1093

SUBJECT: "J" COMPRESSOR DISCHARGE VALVE CAGE BOLT FAILURES

Form 180.23-M2 (SB2)

SUBJECT: "J" COMPRESSOR DISCHARGE VALVE PLATE TORQUES

DESIGN HISTORY

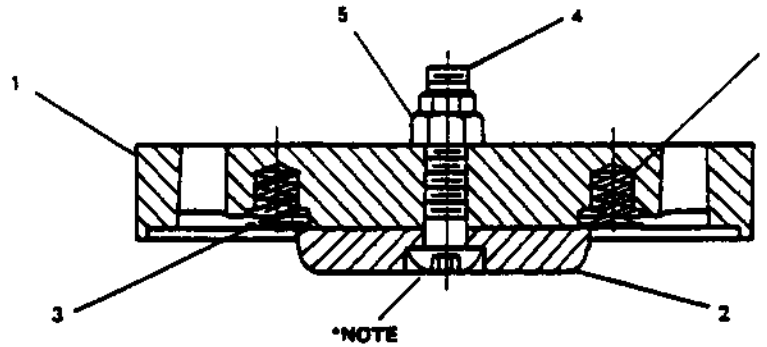
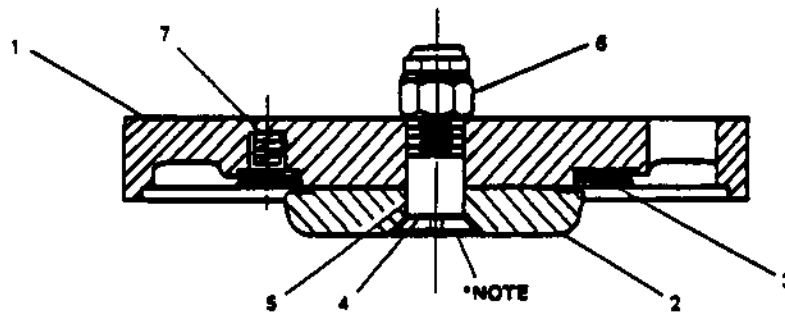
A design change has been made to the Discharge Valve Plate for "J" Model Compressors. Although the change in the design is minor, it is very important to note the torque on the center bolt has changed. The bolts **MUST BE** torqued correctly for each type assembly or damage may occur to the compressor.

CURRENT DESIGN - ITEM #5 TORQUE TO BE 53 - 61 LB. FT.

ORIGINAL DESIGN - ITEM #6 TORQUE TO BE 35 - 40 LB. FT.
